From: "Dave Lochbaum" <dlochbaum@ucsusa.org>
To: <emh1@nrc.gov>, <jag@nrc.gov>
Date: 7/3/02 8:00AM
Subject: More Davis-Besse Questions

**SUBJECT: DICKENS OF A STORY: GHOSTS OF PAST, PRESENT, AND FUTURE
AT DAVIS-BESSE**

Systems Contributing Most to Core-Damage Frequency

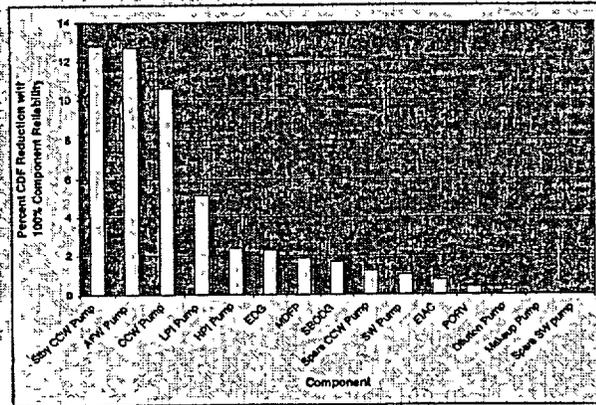
But because the risk assessments assume nearly a zero percent chance of reactor vessel failure, the reactor vessel is not even on the list. It ain't at the top, it ain't at the bottom, it ain't on the list at all. Thus, even if the NRC inspectors were to "bottom fish" and pick the least important systems/components on the list, they still will not audit the reactor vessel.

Yesterday, UCS found a 1999 update to the Davis-Besse risk assessment in the NRC's ADAMS on-line library.⁸ This document confirms our suspicions. The chances of reactor vessel failure was deemed to be 4.5×10^{-7} per reactor year. By arbitrarily assigning an artificially low value that has no real basis, the reactor vessel did not even make the list of risk significant systems and components. What made the list?

The math wizards at Davis-Besse report that the spare service water (SW) pump has essentially no risk relevance, but it is still—according to their goofy Ouija board at least—far more important than the measly ol' reactor vessel head. This hocus-pocus doesn't even pass the laugh test.
